Register Reference : 91A/1255

Applicant : Sean and Dora Kelly

Development : Rehabilitate service station site to include the
demolition of a derelict unserviced dwelling, the
erection of new canopy over 3 no. pump islands, the
provision for a carwash, the erection of a service
area, and the installation of increased underground

LOCATION : Ballynakelly, Newcastle

Client TEXACO (I) LTD TEXACO HOUSE BALLSBRIDGE DA	Scale Date Feb 84 Drawn Checked
Title BOX LETTERS AND LOGO DETAILS	Drawing No 2000/2

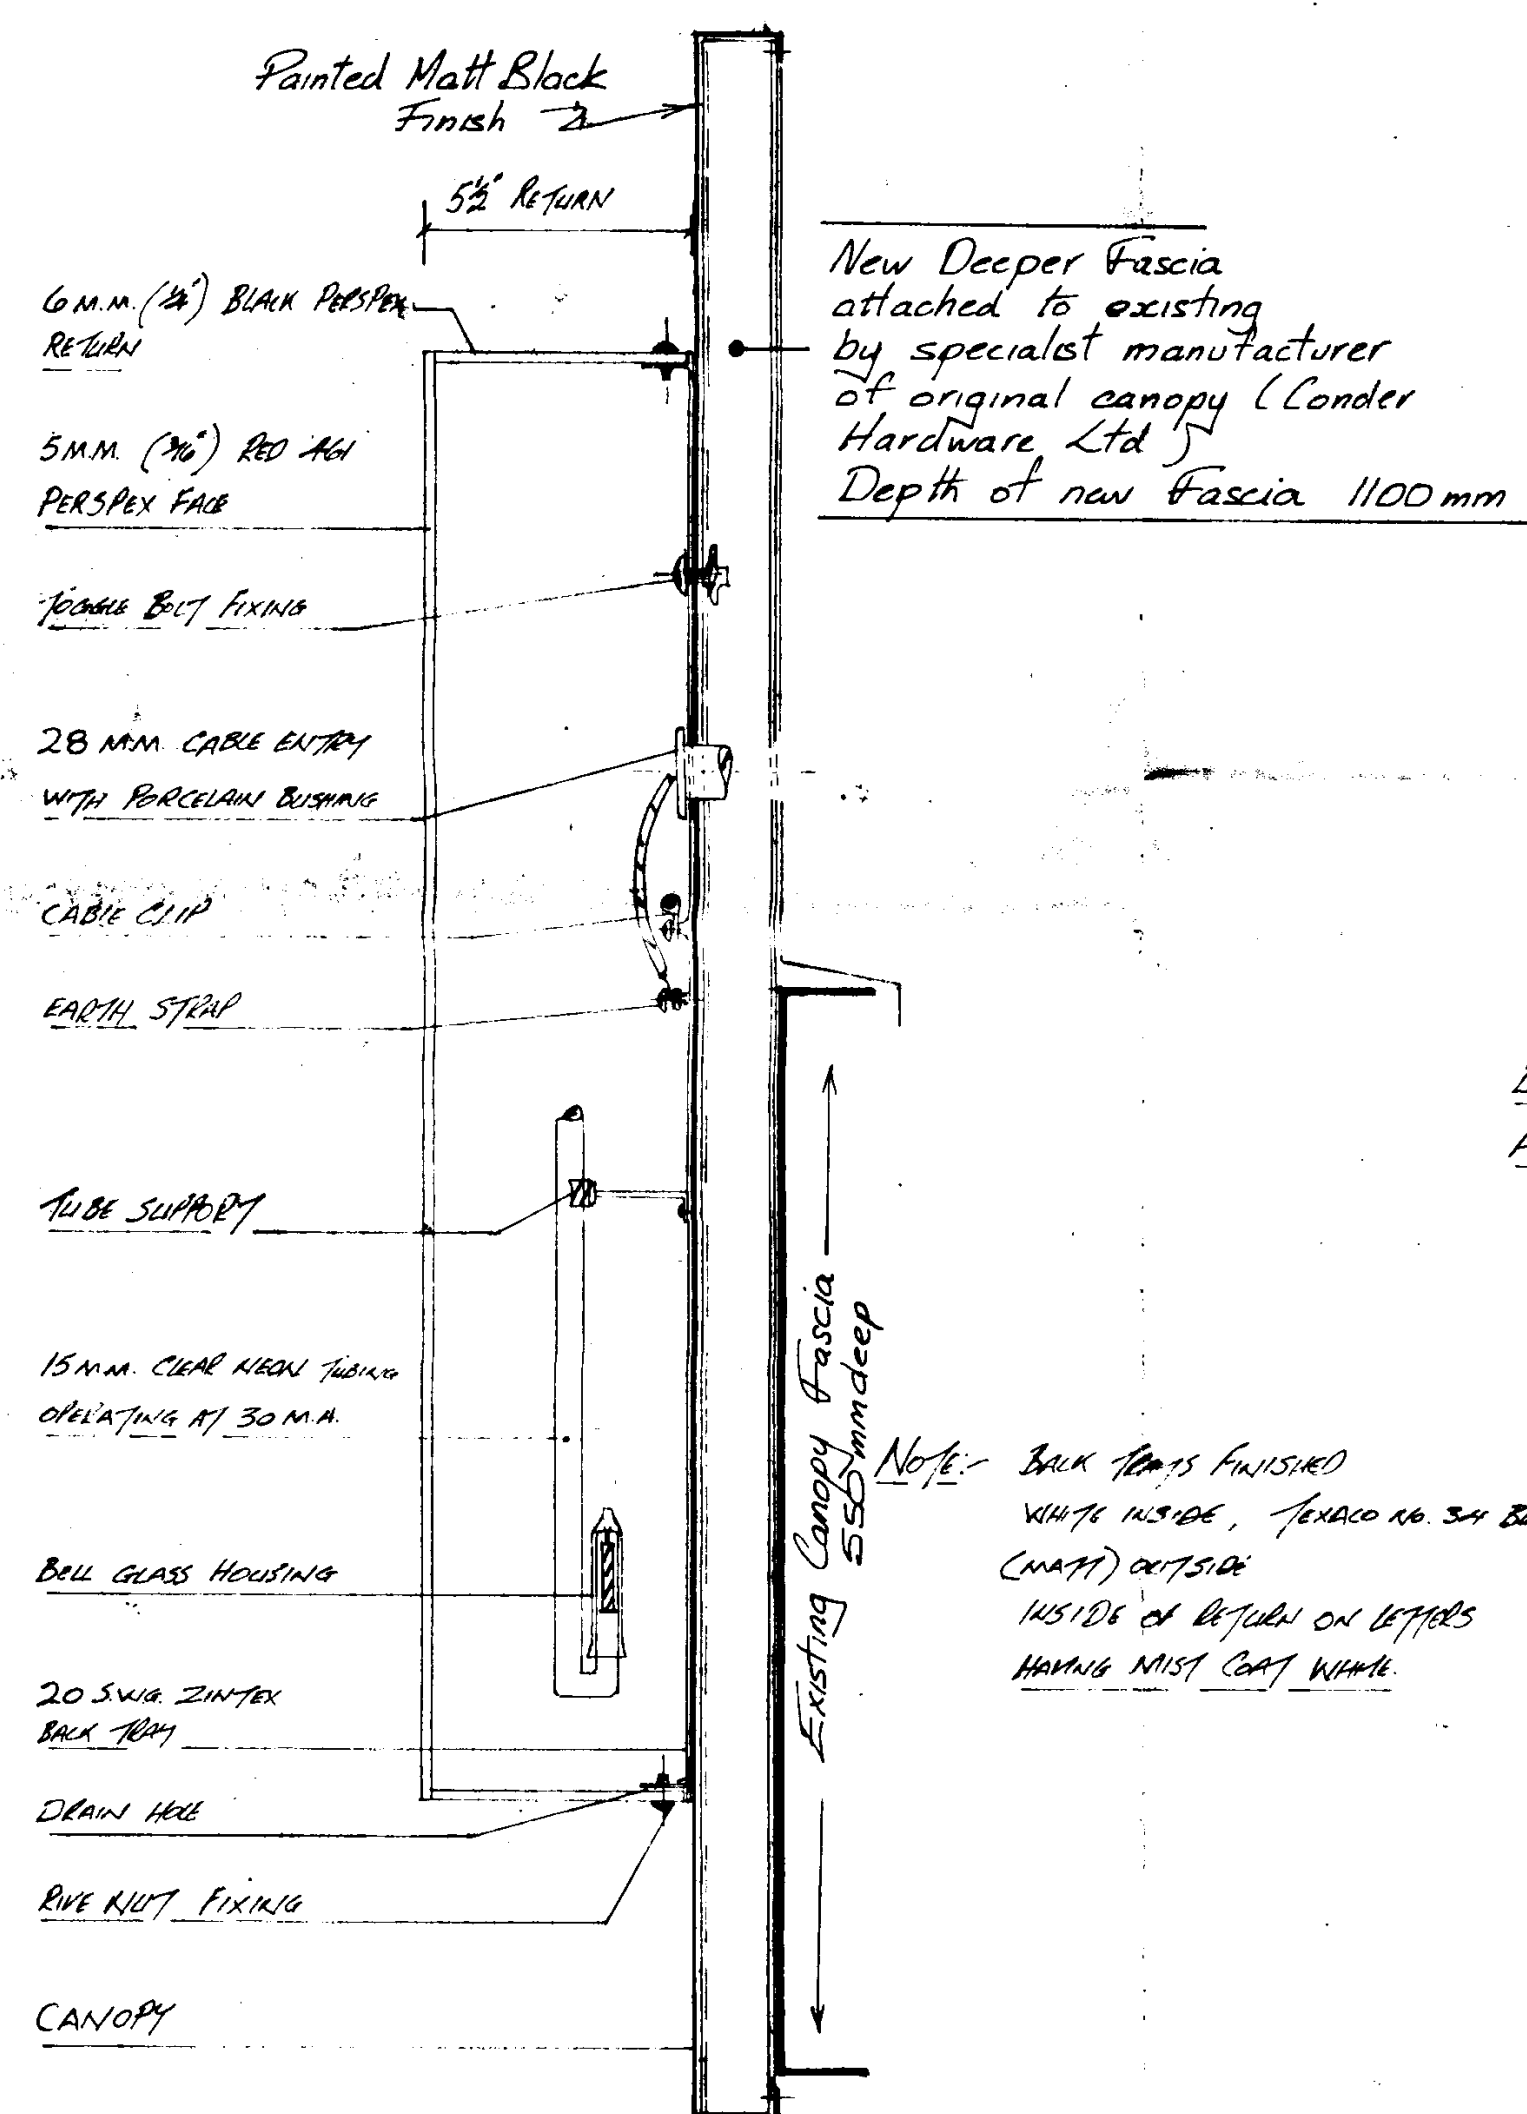
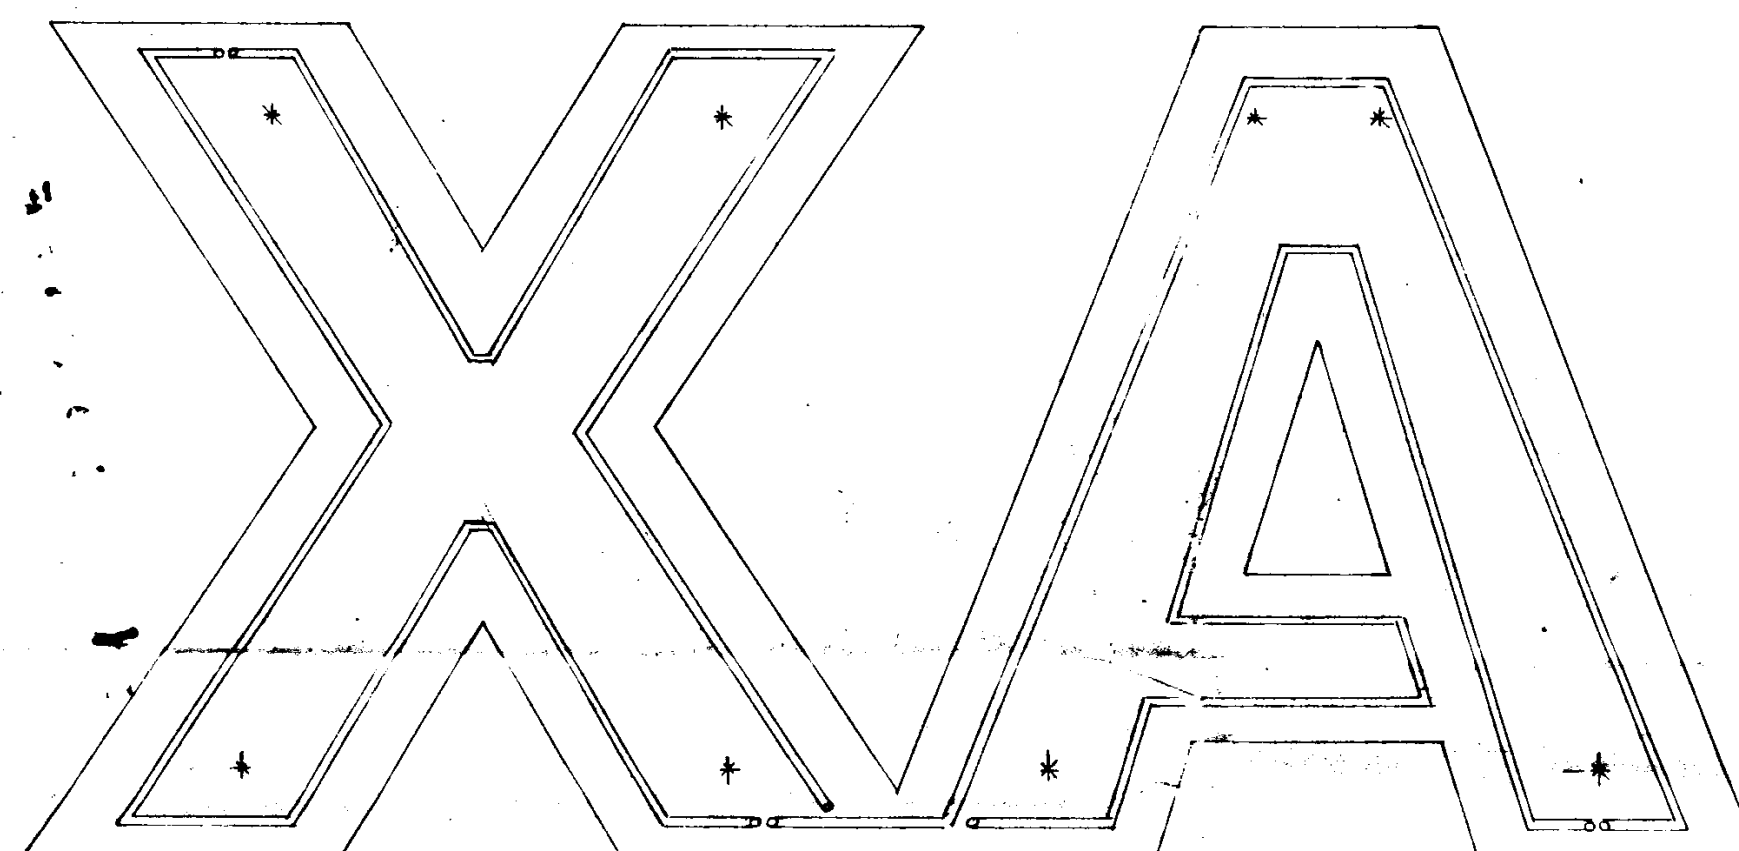
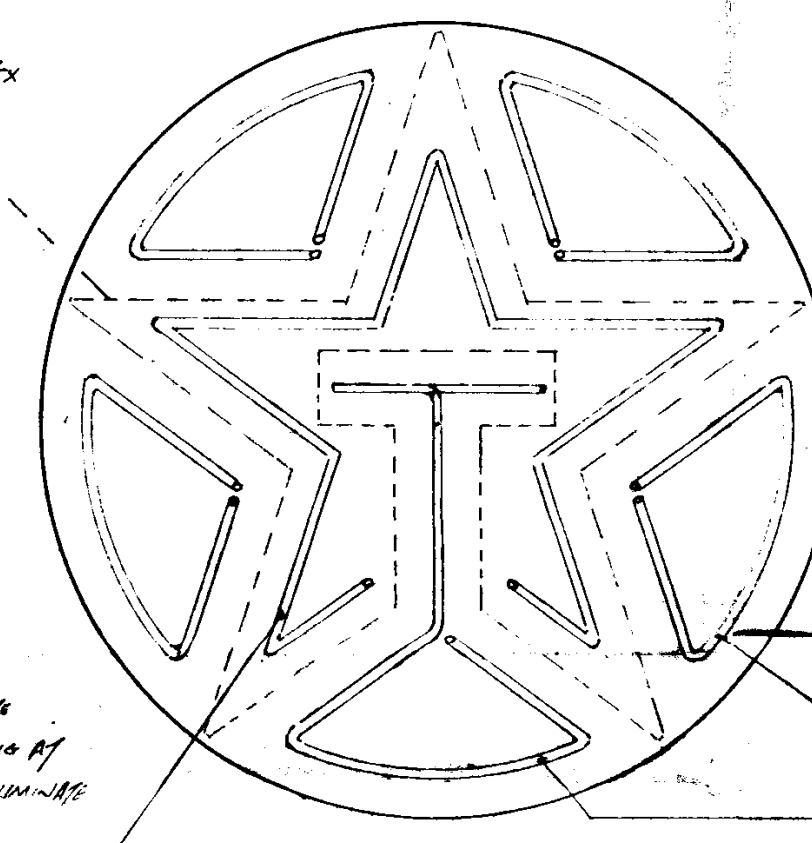
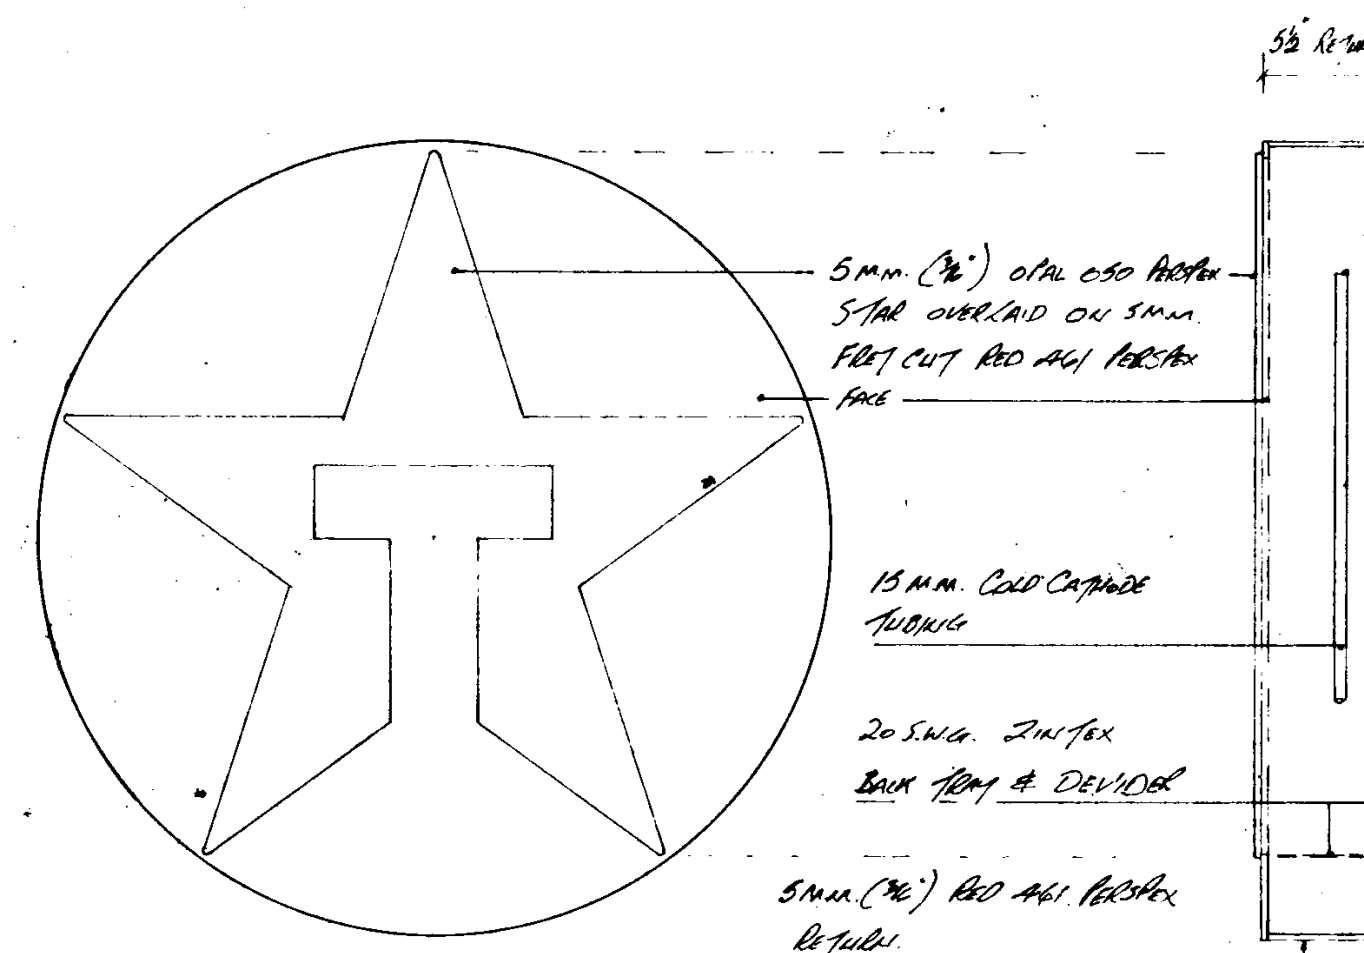
- 04 In view of the location of site within the environs of the village of Newcastle the Planning Authority considers that the amount of advertising ^{is} excessive with regard to size of signs and number of signs. In this regard insufficient information has been submitted of the details of all the signs. The applicant is requested to clarify if he is in a position to scale down the size and reduce the number of proposed signs.

03. The landscaping details are as attached.
04. Reference Drawing No.2002. It is proposed to erect 3 No. sets of Texaco and Star Logo signs on the canopy fascia i.e. 1 set on each side and 1 set on the front. The canopy fascia depth is shown at 1.1M and the proposed illuminated signs are scaled to match this fascia depth. This is a standard signalisation detail for Texaco canopies. We have discussed this matter with the applicants and we would be reluctant to offer to scale down the size or reduce the number of these signs. We do not feel that they are excessive with regard to size or number and we feel, and have been advised, that our canopy fascia signs are the least obtrusive of many corporate signalisation schemes.
